2003 Ford Mustang V8-4.6L SOHC VIN X

INTERIOR - 'A' PILLAR AREA WIND NOISE

02-17-8

NOISE - WINDNOISE FROM THE "A" PILLAR AREA

Figure 1

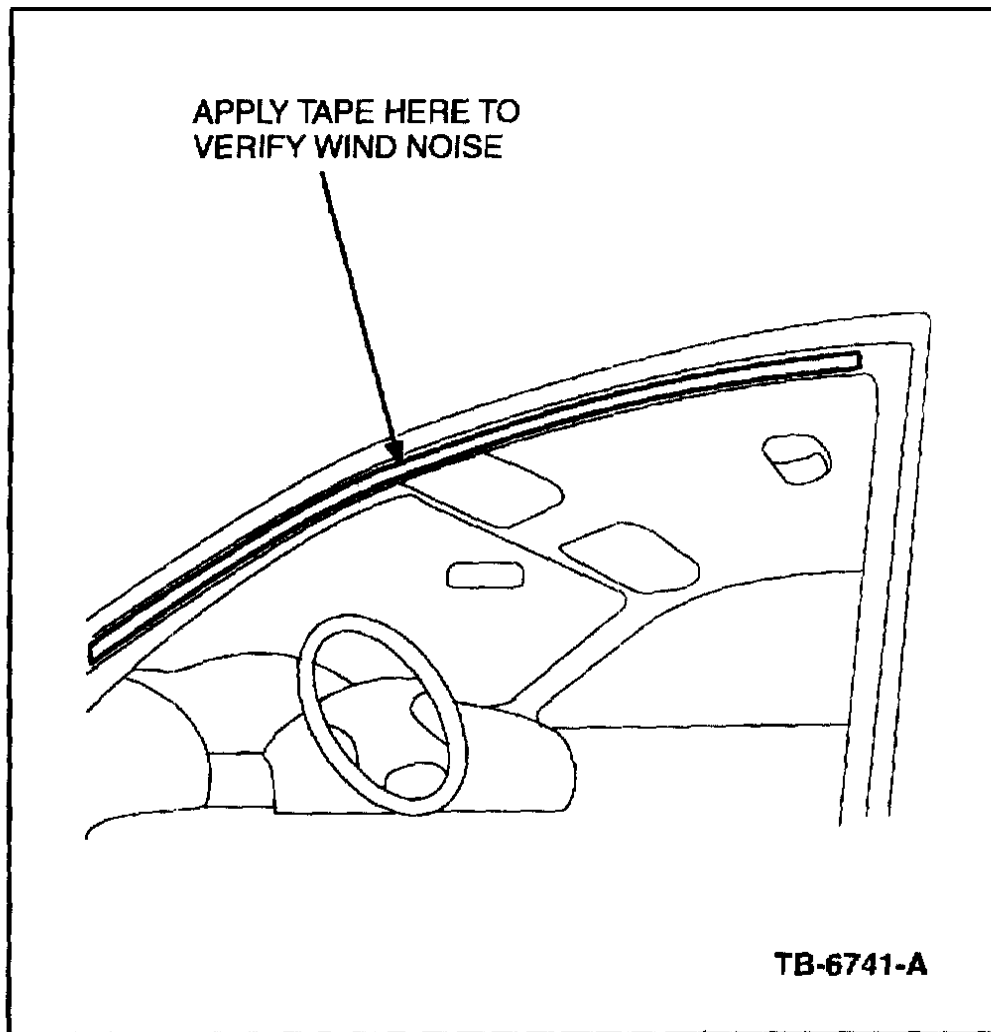
1. Verify windnoise by placing tape the length of the "A" pillar applique (roof moulding) on the door glass side (Figure 1).
2. Drive vehicle and verify that the wind noise is gone.
3. If the noise remains, do not continue with this article. Refer to Workshop Manual Section 100-04 for further diagnosis.
4. If the tape eliminates the noise, remove the tape and remove the A-pillar applique per the Workshop Manual (Section 501-08). Do not continue with the removal of the C-pillar trim.

Figure 2

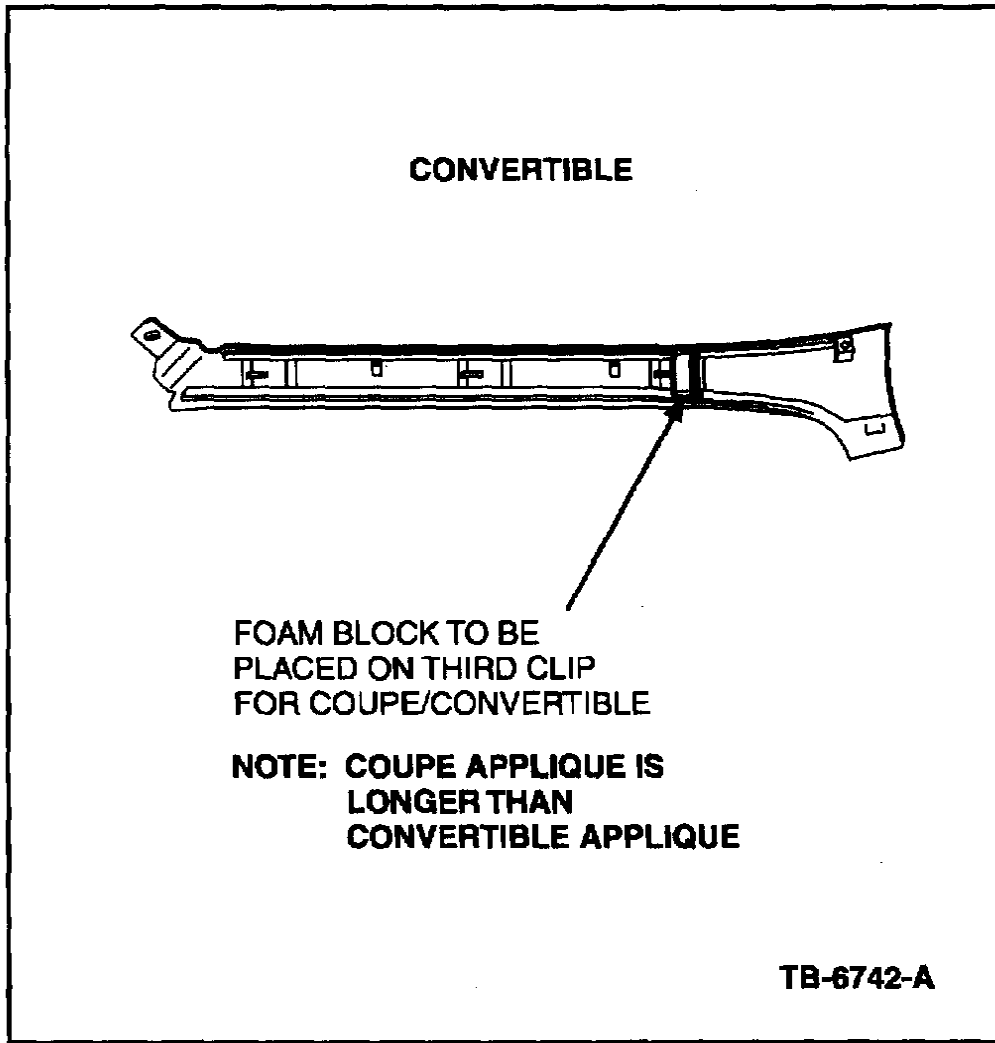
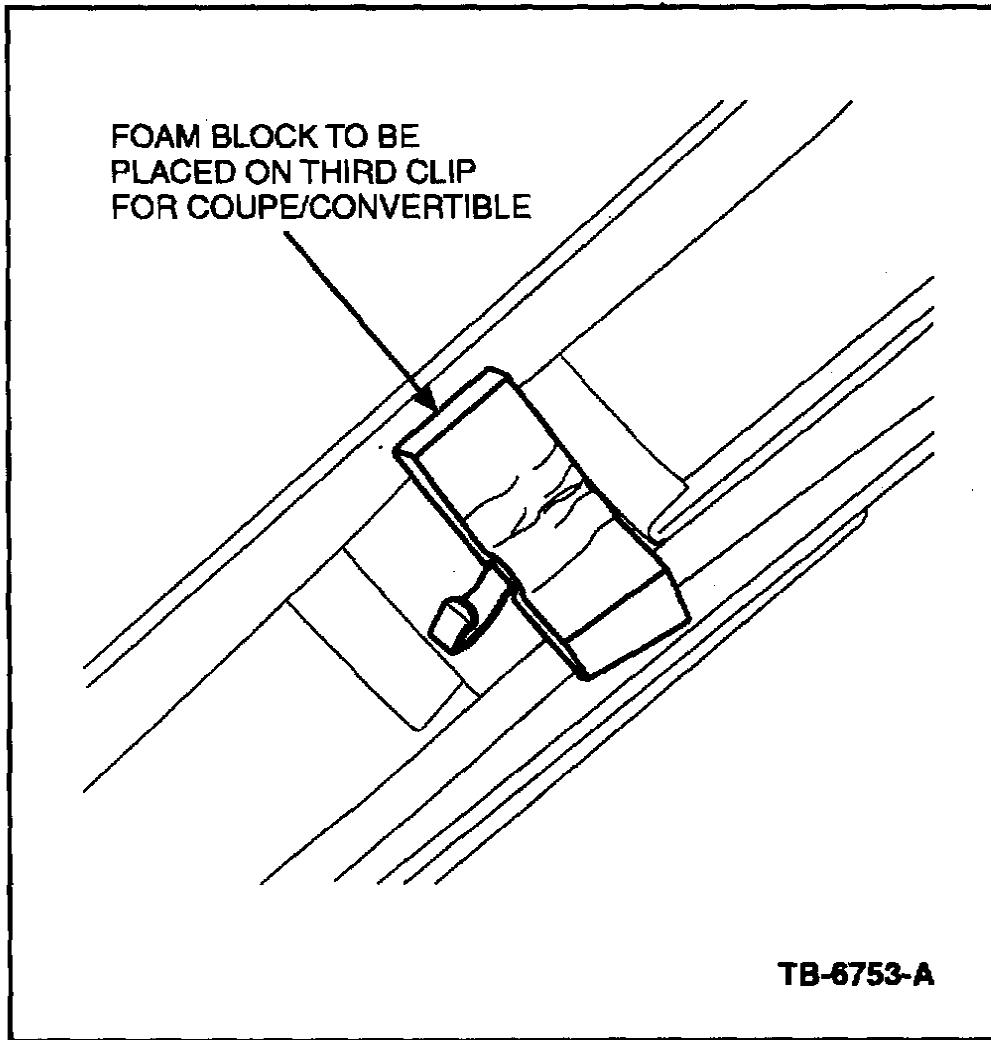
Some 2001-2003 model year Mustangs may exhibit a whistle type windnoise from the "A" pillar area. This may be caused by wind moving over the fastener holes of the "A" pillar applique.

5. Place foam block 2R3Z-63518C46-AA over third retaining hole in applique (Figures 2 and 3).
6. Re-install applique.
